Appendix I of RNTPC  
Paper No. A/YL-TYST/1317

# APPLICATION FOR PERMISSION UNDER SECTION 16 OF THE TOWN PLANNING ORDINANCE (CAP. 131)

# **Proposed Temporary Open Storage and Warehouse for Storage of Construction Machinery and Construction Materials for a Period of 3 Years**

**Lots 1311 S.A (Part), 1312 (Part), 1313, 1331 S.B ss.1 & 1331 S.B RP (Part) in D.D.119, Yuen Long, N.T.**

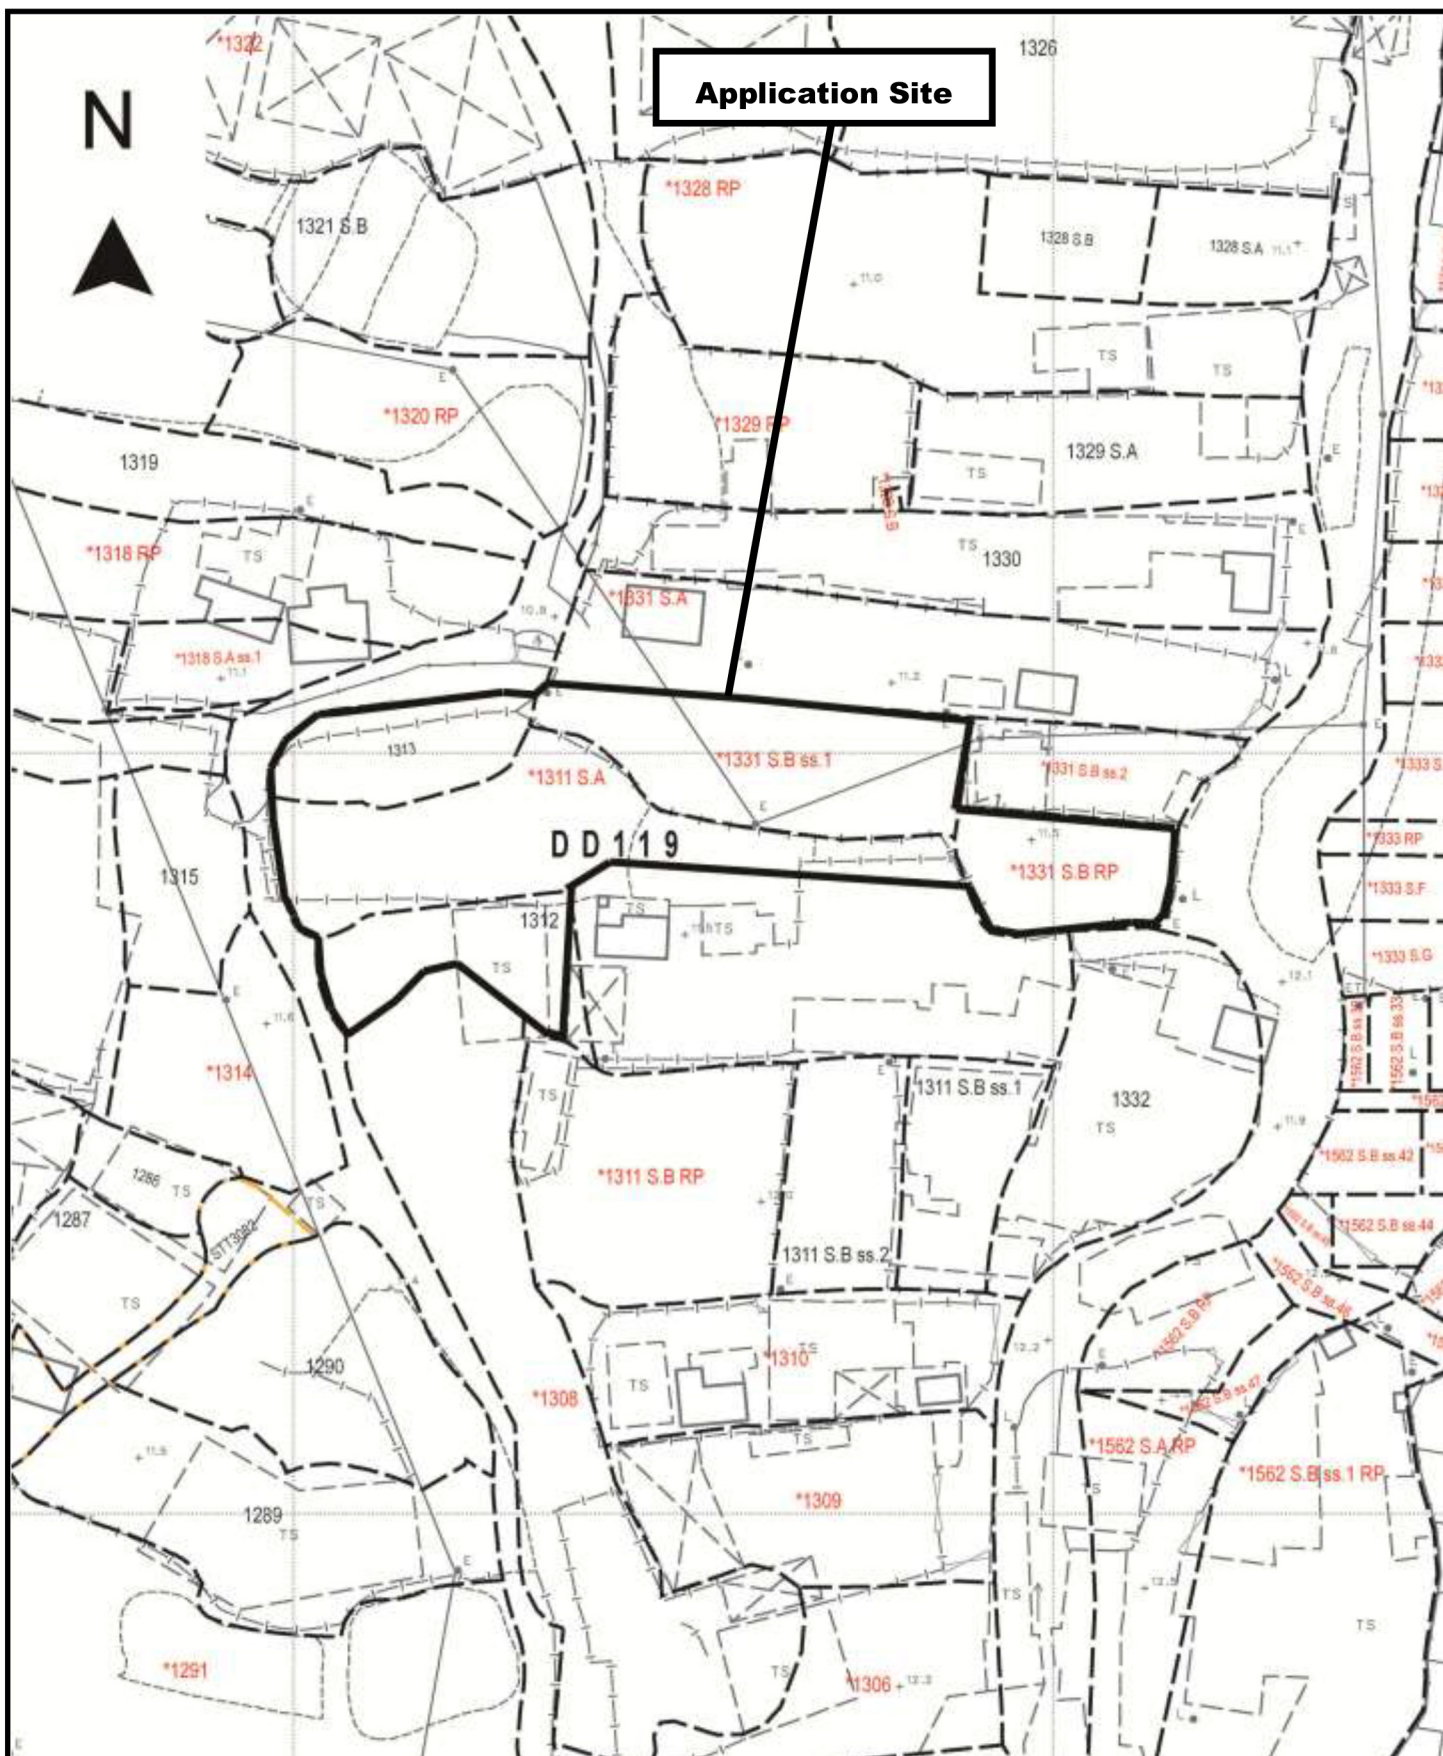
- (i) to note the general comments of the Chief Engineer/Mainland North, Drainage Services Department (CE/MN, DSD) and his technical comments on the submitted drainage proposal that:

- (i) the applicant should advise if any site formation/levelling works to be carried out under the application. Cross sections showing the existing and proposed ground levels of the Site with respect to the adjacent areas should be given;

- (ii) the cover levels and invert levels of the proposed U-channels, catchpits/sand traps should be shown on the drainage plan;
  - (iii) according to paragraph 1.3.7 (c), it is noted that a 100mm openings will be provided at the toe of hoardings. Its details should be provided on the drainage plan in Figure 4 for reference;

- (v) further to (iv) above, since there is no record of the said discharge path, site photos at different locations and views should be provided to demonstrate its presence and existing condition. The size of the existing open drain should also be indicated on the drainage plan and the applicant should check and ensure the hydraulic capacity of the existing drainage facilities would not be adversely affected by the development;
